REPORT

132kV SUBTRANSMISSION DEVELOPMENT, TUGGERANONG, A.C.T.

(Nineteenth Report of 1984)

Causeway to Gilmore line - northern section. Location in relation to existing and proposed land uses

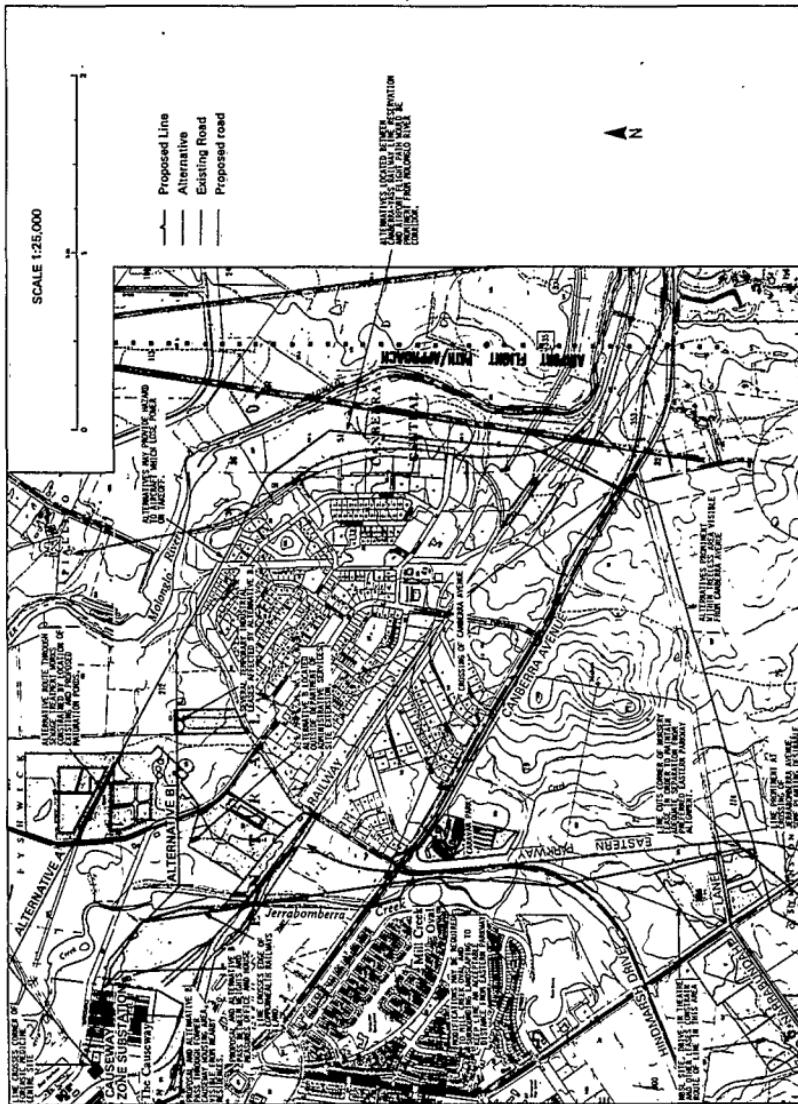
58. Impact on current land use Although in the Causeway area the line would traverse land that is below the 100 year flood level and has not yet been redeveloped it would have a significant visual impact. The line would be partly screened by established deciduous trees, however, additional screen planting would be necessary. The positioning of the line could render the land unsuitable for any future housing development.

59. Just south of Canberra Avenue the route is tightly constrained by the Hindmarsh Drive/future Eastern Parkway road reservation, Jerrabomberra Creek and the Mill Creek Oval. Unless an alternative route is adopted the line would have an impact on at least one of the abovementioned land uses. In order to keep its support structures a safe distance from the future Eastern Parkway, the line may encroach upon Mill Creek Oval, which the Committee was informed is one of the more popular ovals in inner Canberra, and would severely limit its use as a football or cricket ground. An option is to remove a stand of rusted poplars currently lying between the oval and the road and route the lines through there. However, apart from the line then being highly visible, this option would create a safety hazard as the oval is sometimes used for kite and model aeroplane flying. An alternative would be to couple this option with relocating the oval and planting a replacement row of poplars.

60. In the Narrabundah Lane area the proposed route would cut across the corner of a lease currently held by a plant nursery. Although the line would not affect operations there, it would preclude the future construction of buildings should the lessee wish to expand. Additionally, the lessee is required by the terms of the lease to plant tall trees around the boundary of the site, and this would not be possible to comply with. The ACTEA advised, however, that the route again is dependent on the final alignment of the Eastern Parkway and the encroachment may not occur.

74. Committee's Conclusion Although the proposed Causeway to Gilmore subtransmission line will have an adverse impact on land uses in certain places, it is acceptable. It has been designed to be as minimally intrusive as possible while still being able to cater for present and possible future power requirements. Alternative routes are longer, more costly and less desirable.

Causeway to Gilmore line - southern section. Location in relation to existing and proposed land uses

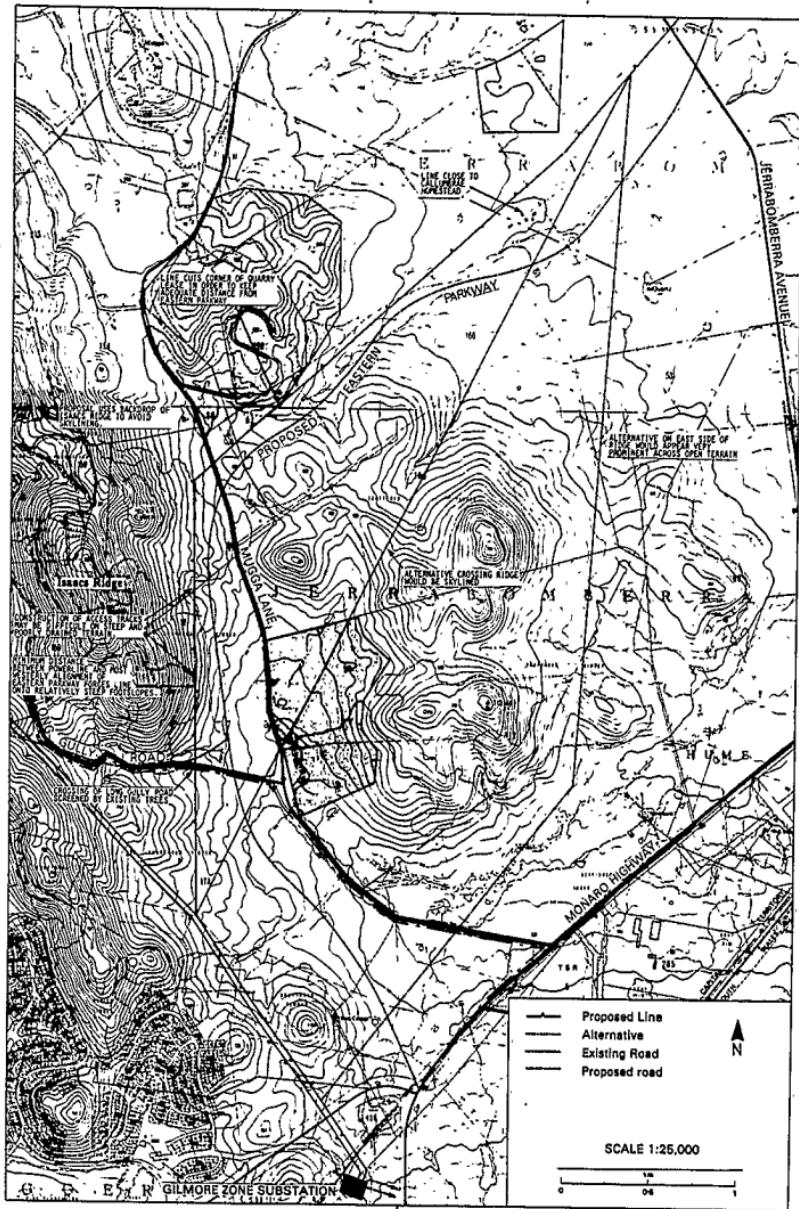
61. Further south the proposed route would enter the desirable clearance zone for the Bonshaw Naval Receiving Station. Although high voltage powerlines are a particular source of interference to radio reception, the Committee was informed that the extent of interference could not be gauged in absolute terms and the development was only one of an increasing number of activities in Canberra and Queanbeyan which could eventually lead to the station's relocation.

62. Most of the remaining land traversed by the powerlines is used for grazing and would not be affected significantly. Although they would pass close to the Callumbrae homestead, reducing its aesthetic appeal, the ACTEA believes the visual and ecological impact can be minimised through close consultation with the lessee.

63. The route also would bring the powerlines close to the BMG quarry. Concern was expressed that interference could cause premature ignition of electric detonators, a potentially hazardous situation. The ACTEA informed the Committee that less than 25 metres of the route would cross the quarry, and provided proper precautions were taken, powerline induced detonations should not be possible.
